AMENDMENT OF SOLICITATION/MODIFICATION OF CONTRACT		1. CONTRACT ID CODE	PAGE 1	OF PAGE(S) 17
---	--	---------------------	------------------	----------------------------

8. NAME AND ADDRESS OF CONTRACTOR (No. Street, county, State and ZIP: Code) Potential Offerors: Cooling Tower Rehab Solicitation	(4)	9A. AMENDMENT OF SOLICITATION NO. NNC12ZFD011E
	X	9B. DATED (SEE ITEM 11) Feb 28, 2012
		10A. MODIFICATION OF CONTRACT/ORDER NO.
		10B. DATED (SEE ITEM 13)

QUESTIONS AND ANSWERS

Reference for Question 8 and 9 with an excerpt from the GRC CT 1 & 4 system P&ID

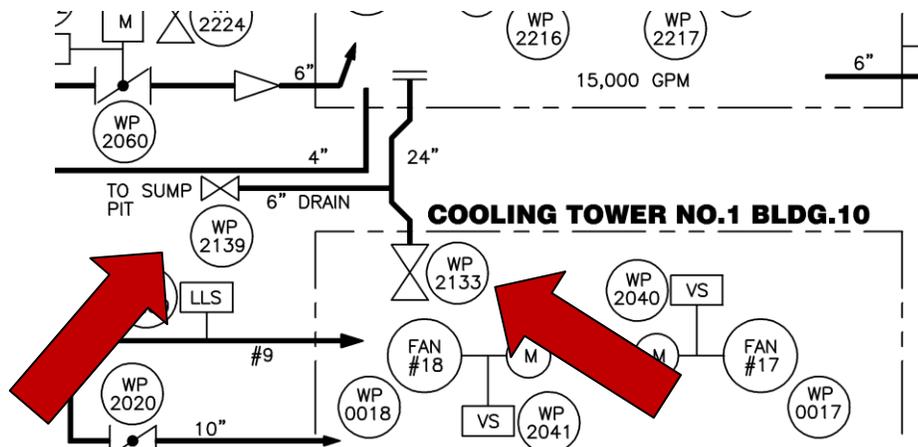
8. **Drawing CE-0010-COF13572-MJ-101, valve# WP2139 is tagged with note 2 indicating that it is a 10" valve is this correct?**

9. **Valve # WP2133 what size is this valve?**

Valve ID # WP-2139 is a 6 inch valve.

The indicated note 2 on the drawing is not correct for the valve ID WP-2139.

Valve WP-2133 is a 24 inch diameter valve. The valve replacement will be provided as Government Furnished Equipment (GFE). Contractor will remove the existing valve and install the provided valve.
